Alton Estate Regeneration
Hybrid Application

ARBORICULTURAL ADDENDUM

Arboricultural Addendum

for planning application 2019/2516

Figure 1: Excerpt from the DAS Addendum showing revised tree removals and planting plans.

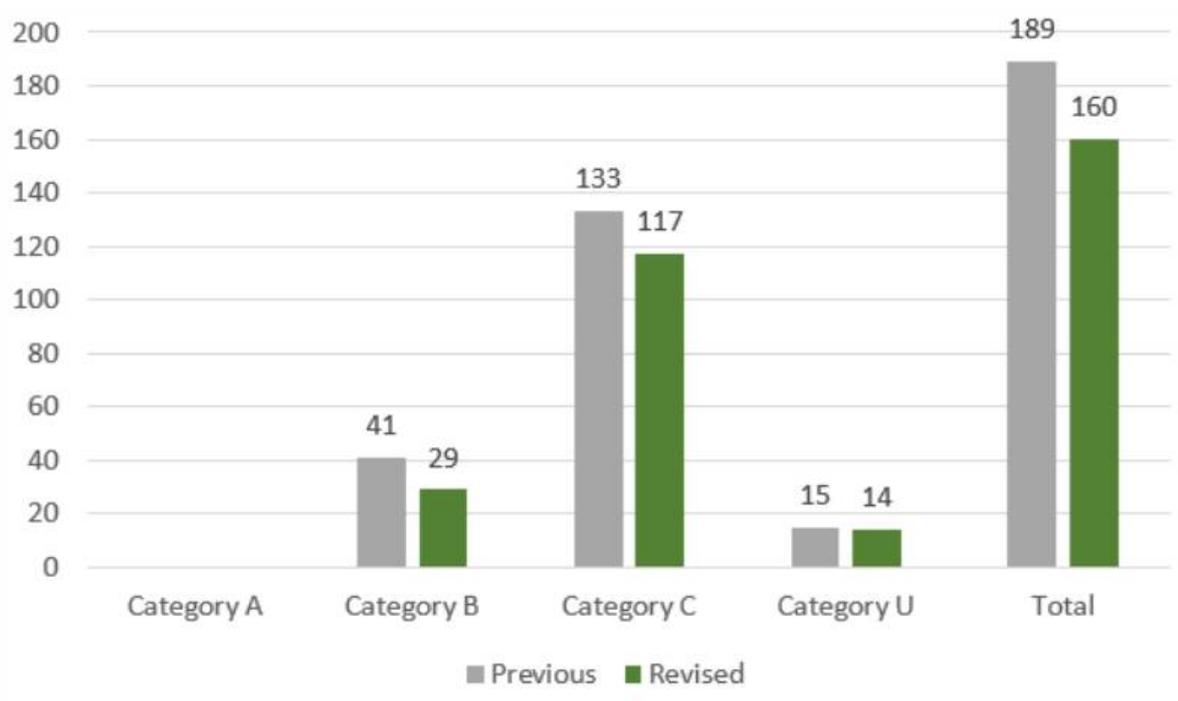
- 3.1 As a consequence of the retention of 29 additional trees along Harbridge Avenue, a total of 160 trees are now proposed for removal (see Figure 2 below and Appendix E, for further details), which is a decrease from the 189 trees originally proposed for removal - this calculation does not include the management of tree groups including partial removals of such groups, which have estimated (indicative) numbers.
- 3.2 Importantly, this includes the retention of 12 additional B-category trees, which includes all of the lime trees along Harbridge Avenue except for T111 (see Figure 1 below). These reduced tree removal numbers are coupled with new tree planting, which includes 169 private trees and 564 public trees, amounting to a total of 733 new trees (a net gain of 573 trees). 20 of these trees will be planted, along Harbridge Avenue.
